To	Mayor and Council & Colin Smith, Chief Administrative Officer Town of Riverview	Item
From	Kirk Brewer Planner	Meeting Date
Date	March 20, 2024	
Subject	By-law 300-7-15: Rezoning from SC to CM – Cleveland Avenue	
Length of presentation (if applicable)	10 minutes

Ashish Goel is proposing two six-storey buildings on the newly extended section of Cleveland Avenue, which is zoned Suburban Commercial. This zone limits height to 15m, which would not allow six storeys. As such, a rezoning is required to permit the additional height and density.

SITE PLAN

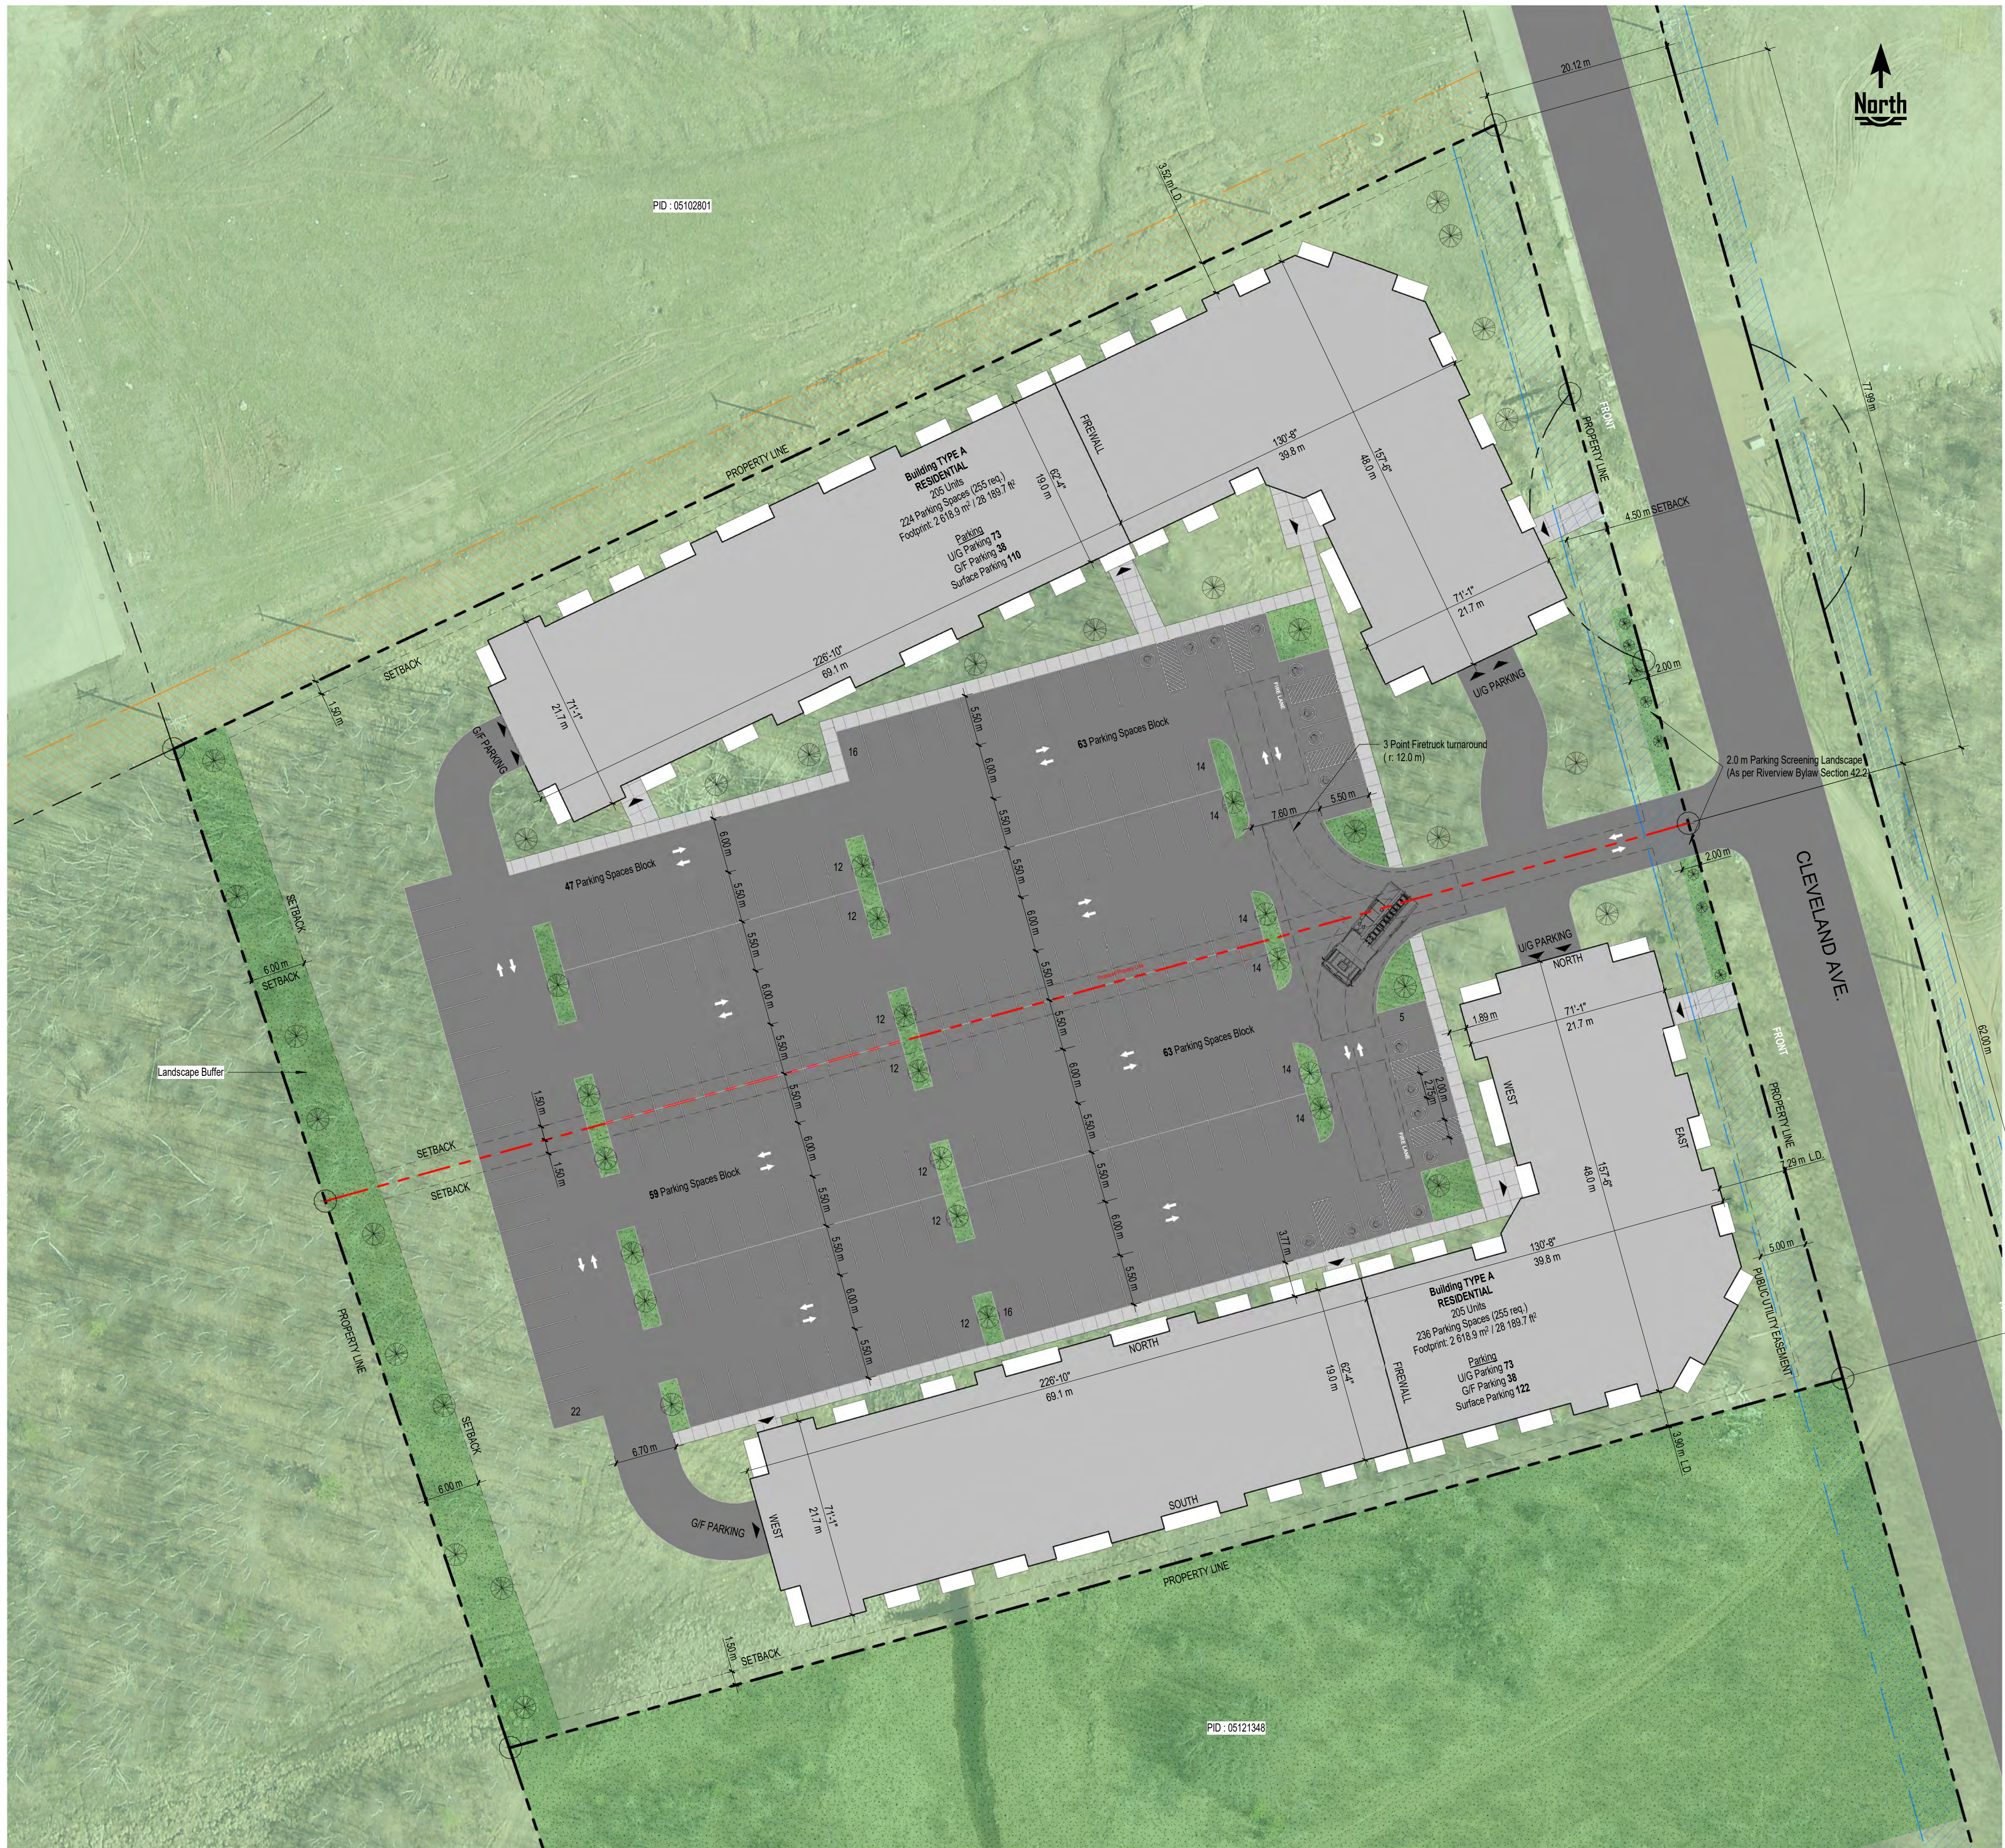
- 2) The multi-unit building standards limit parking lot coverage to 35% of the overall site. In this case, if the property were divided in two, one half would comply with the by-law (34.6%) and the other half would exceed (38.3%). The total parking lot coverage for the project averages 36.45%, so a variance is being requested. Staff considers this variance minor and reasonable, considering that reducing the size of the parking lot would remove parking spaces and increase the space per unit variance request.

- 3) Finally, the zoning by-law requires that where a multi-unit building does not abut an R1, R1C, or R2 zone, that a 3m wide landscaping buffer be provided between properties. In this case, the 3m buffer is being met to the west and south, but due to a French drain and natural gas line running along the northern property boundary, it is likely not possible to meet the tree planting requirement. Since the buildings will have indoor parking garage access from the access driveway, moving the northern building to increase the landscape area may interfere with garage access. In this case, staff feels it is reasonable to waive the tree planting requirement to the north without requiring a fence, since the property to the north is currently vacant, and will likely develop as a commercial or multi-unit building that will need to provide landscaping on the adjacent property.

ELEVATIONS

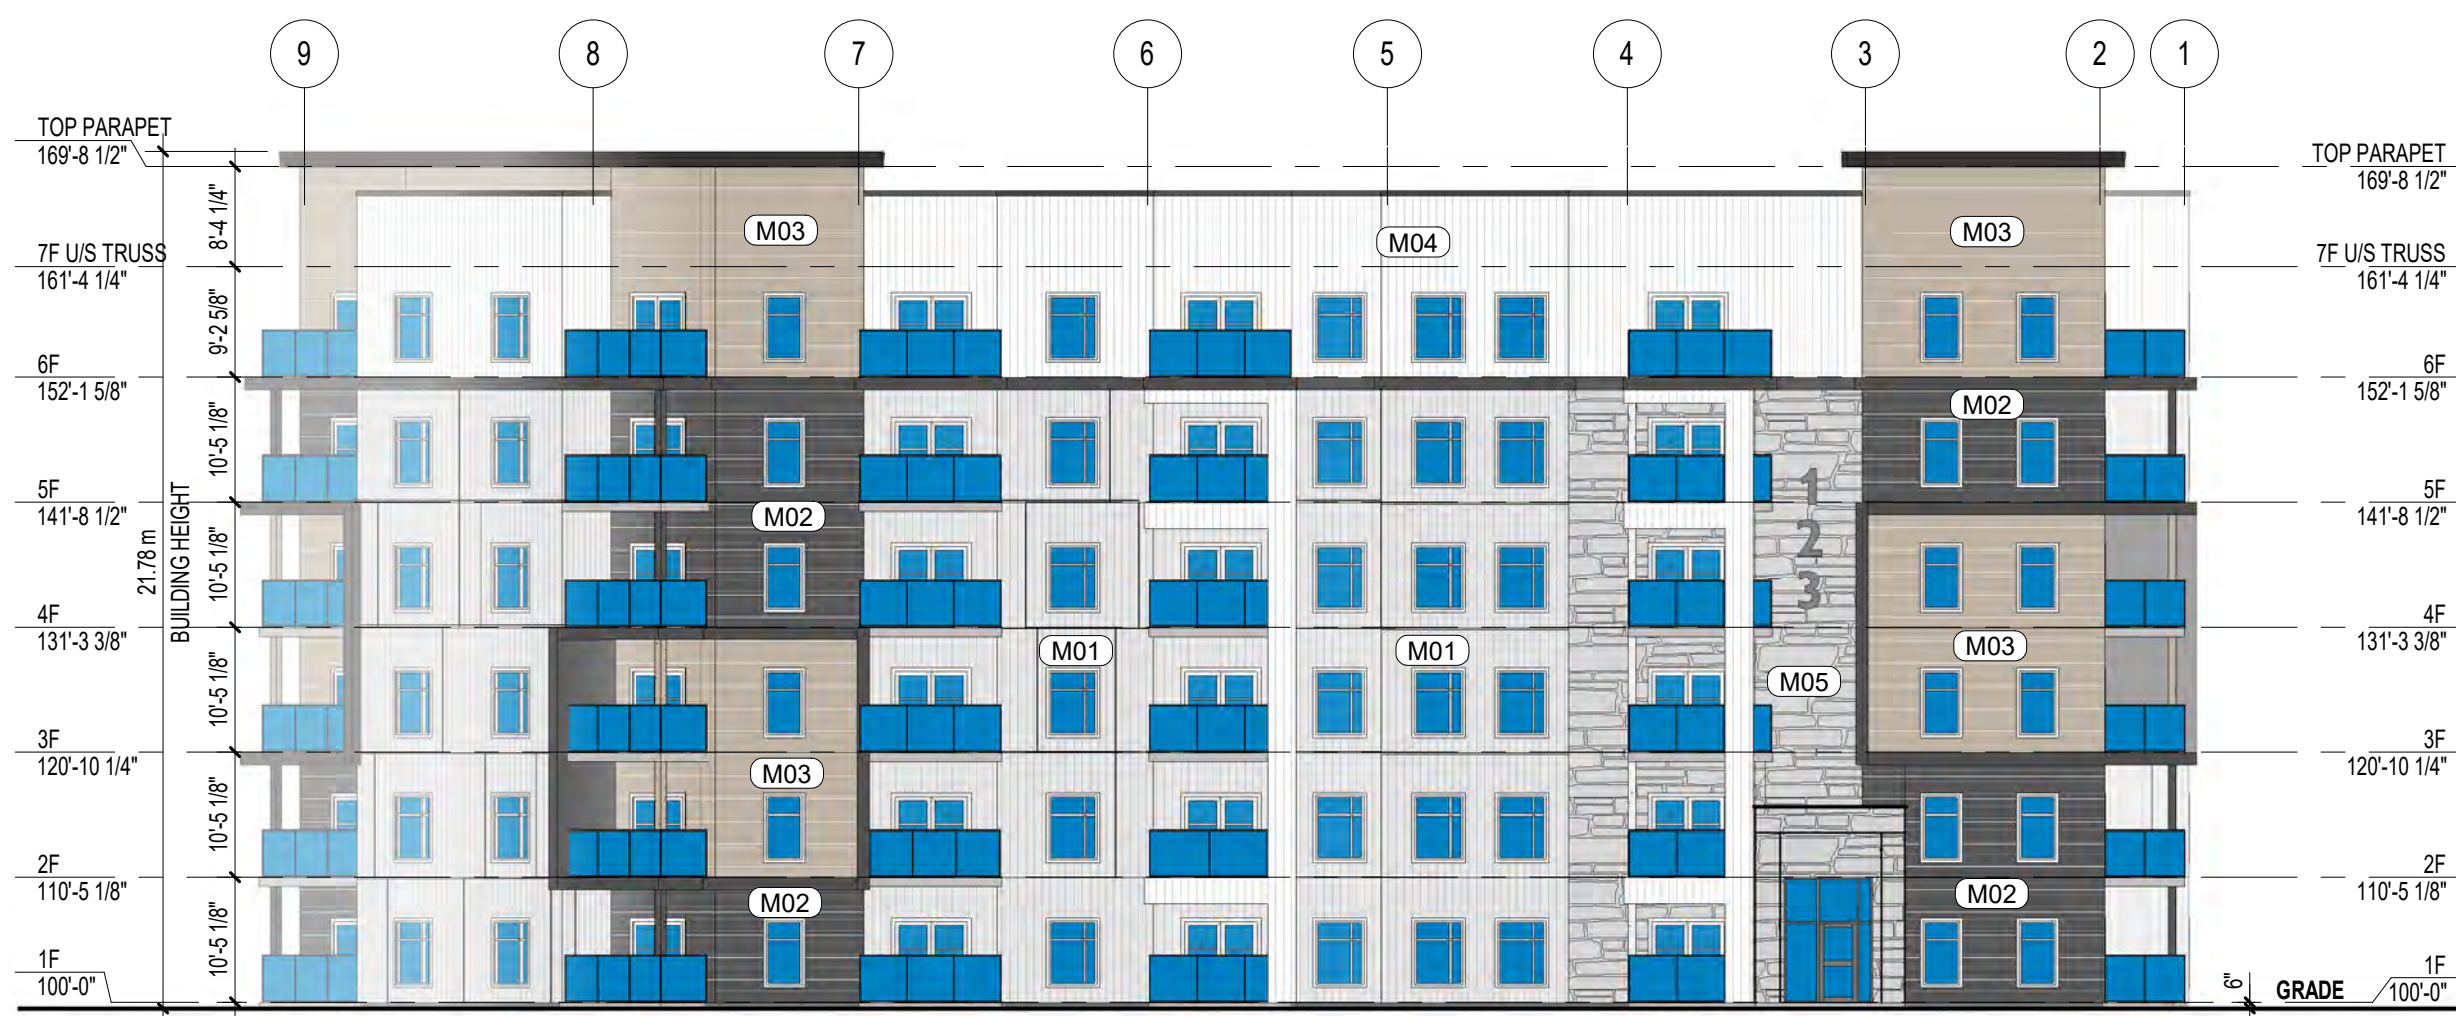
The CM zone allows up to 18m (60 ft) in height. This height limit assumes an average floor height of 3m (10ft), which would allow six storeys. While the final building height has not been determined, it is anticipated that the proposed design will exceed 18m, and as such will require a variance. The building elevations indicate a height of 67 feet (20.4m) to accommodate the roof truss system, but the design team has indicated this number may change slightly as plans are finalized at the building permit stage.

Staff is comfortable recommending a height variance of up to 21m to allow limited flexibility in the final building height while limiting the number of storeys to six in order to respect the intent of the zoning by-law. At six storeys, this height increase should not be visually perceptible, and will not create any negative impacts on neighbouring properties. Further, staff intends to review the maximum allowable height in all zones as part of the municipal plan review to ensure heights align with current industry practices.
